# IEEE P802.3az/D1.1 Clause 40 PHY Control State Diagram Corner Case Analysis

Xiaotong Lin and Mike Grimwood, Broadcom

IEEE P802.3az Task Force  
New Orleans, January 2009

# Clause 40 PHY Control State Diagram A

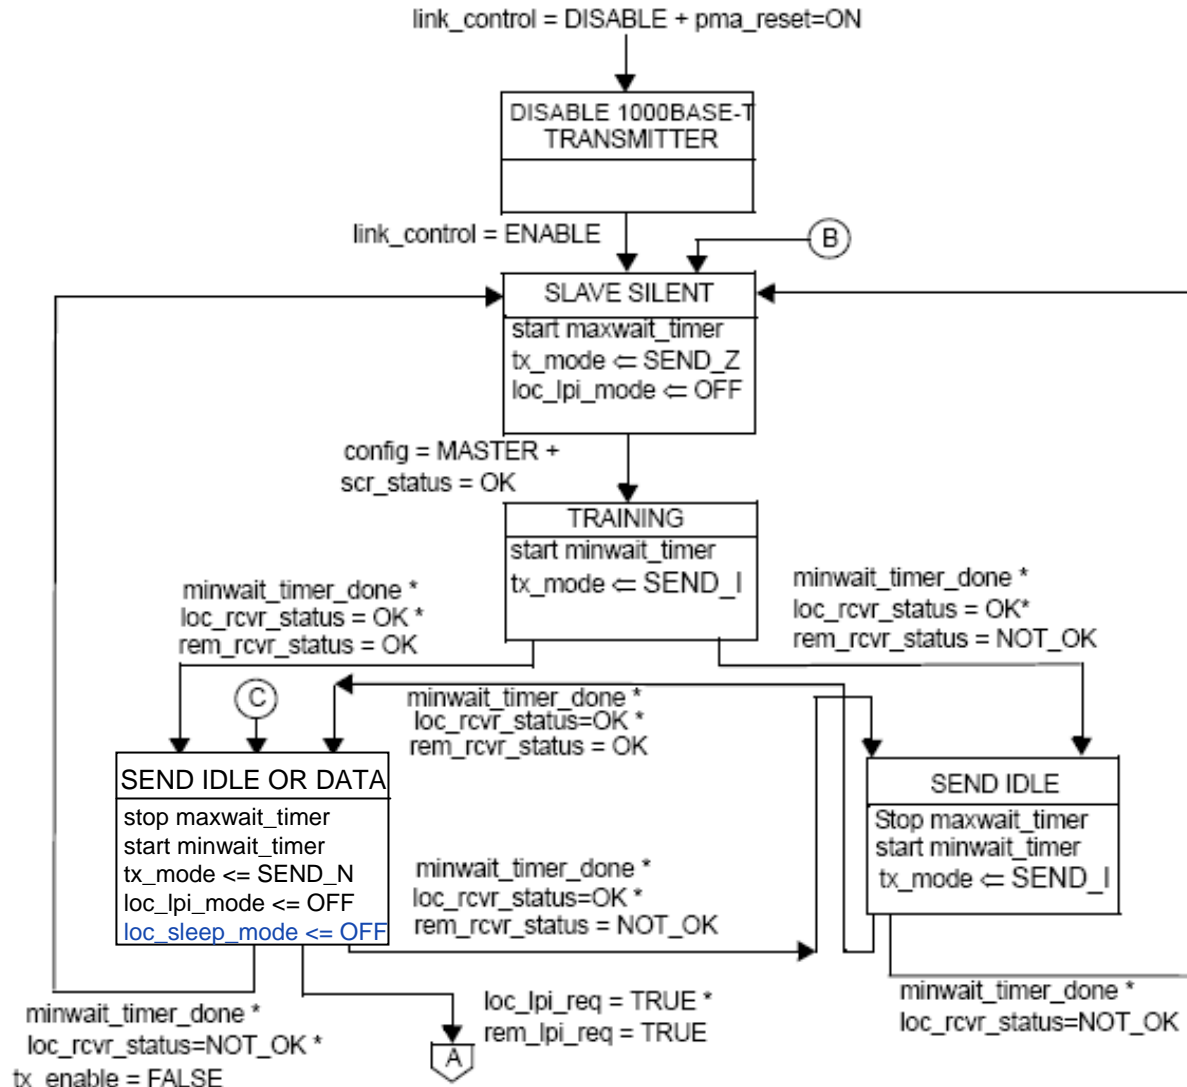
- In the PHY Control State Diagram in Figure 40-15b, a corner-case, out-of-sync condition can occur under the following conditions:
  - loc\_lpi\_req changes to FALSE.
  - The local link partner is near the end of its WAKE\_TRAINING state.
  - The remote link partner has transitioned from WAKE\_TRAINING to UPDATE.
- This presentation illustrates this corner case and proposes a change to avoid it.

(Proposed Change in Blue)

- Modify PHY Control State Diagrams using `*sleep_mode` instead of `*lpi_mode` (as on slides 4 and 5)
  - In Figure 40-15a, in the SEND IDLE OR DATA state, add "`loc_sleep_mode <= OFF`".

# Clause 40 PHY Control State Diagram B

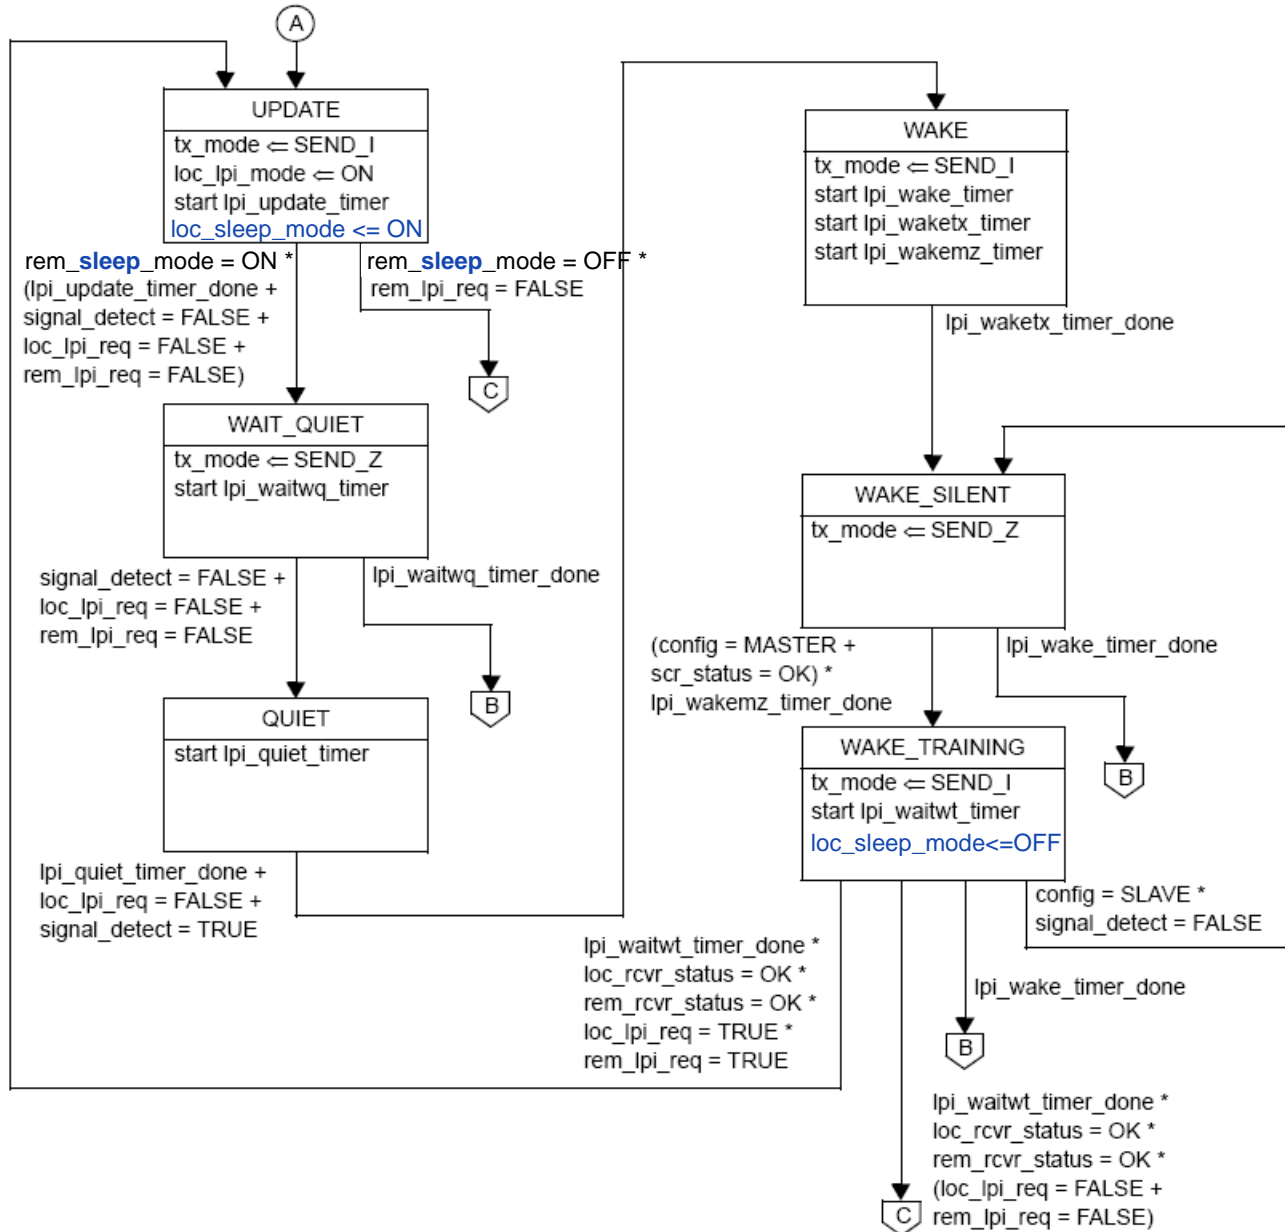
(Proposed Changes in Blue)

- In 40-15b, PHY Control State Diagram
    - Change `*_lpi_mode` to `*_sleep_mode`.
    - In `WAKE_TRAINING` state, add "`loc_sleep_mode <= OFF`".
- Encode `loc_sleep_mode` in place of `loc_lpi_mode`
